service bulletin

NUMBER: 84-12

A. Merc 2.2 Serial Plate

B. Remote Control Cable Retainer P/N 42846A2

B. REMOTE CONTROL CABLE RETAINER P/N 42846A2

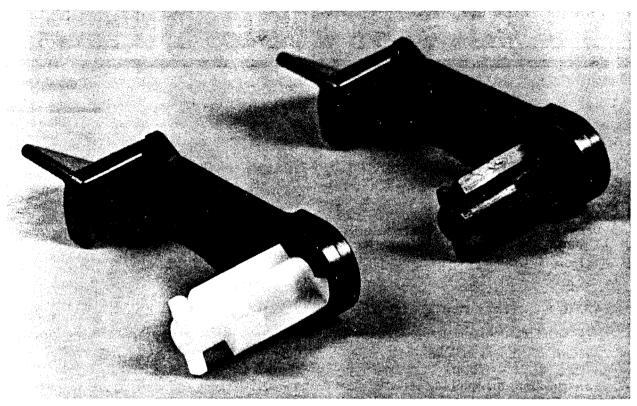
Remote control cable retainer has been revised (and superseded) to ease assembly and to better insure retention. The new revised retainer has a white pivot shaft for easy identification, the original retainer was all black. (Figure 2)

New Retainer (White Pivot Shaft)

Old Retainer (All Black)
